**PLANNING AND DEVELOPMENT SERVICES STAFF REPORT**

**For Planning Commission Meeting of August 1, 2017**

**SUBJECT: 1140 Broadway Conditional Rezoning and Site Plan with Planned Project and Chapter 62 Landscape Modifications**

**File No. SP17-009, Z17-0003**

**PLAN ENHANCEMENTS**

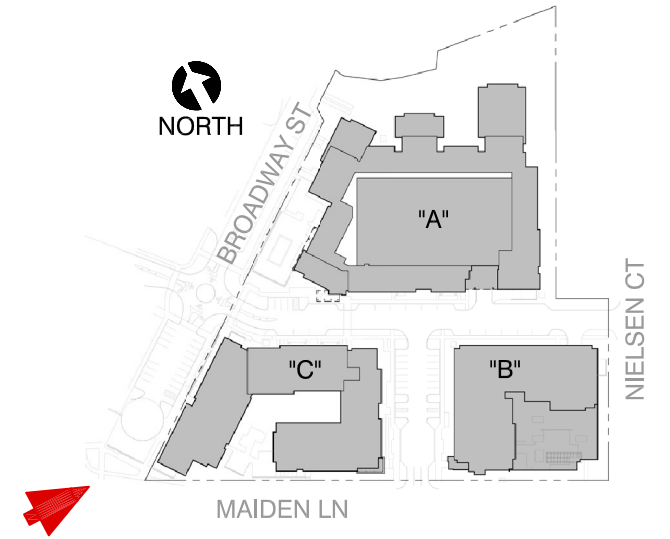
- **HEIGHT - Adjacent to Creek**  
Reduced all three wings to 4 stories to comply with the Master Plan recommendation. Relocated mass toward south, to other portions of Buildings A and C.

- **SETBACK - Adjacent to Creek**  
Increased Building A setback by reducing the length of its northeast wing by 17 ft.
- **TRAVER CREEK ACCESS**  
Added a meandering, 7 ft. wide path that runs parallel to the Creek. Path is located outside of the wetland buffer, with minimal natural feature disturbance.

- **POOL**  
Increased setback to 10 ft. to eliminate planned project modification. Lowered screen wall from 8 ft. to 6 ft. and replaced a section of it with ornamental fence to increase transparency.

- **LOWER TOWN GATEWAY**  
Revised concept to provide better views into site and increased bench seating.
- **RETAIL**  
Extended footprint further along Maiden Lane to activate the street. Reconfigured plaza.

- **MAIDEN LANE SIDEWALK**  
Increased width to 8 ft. to improve pedestrian circulation.
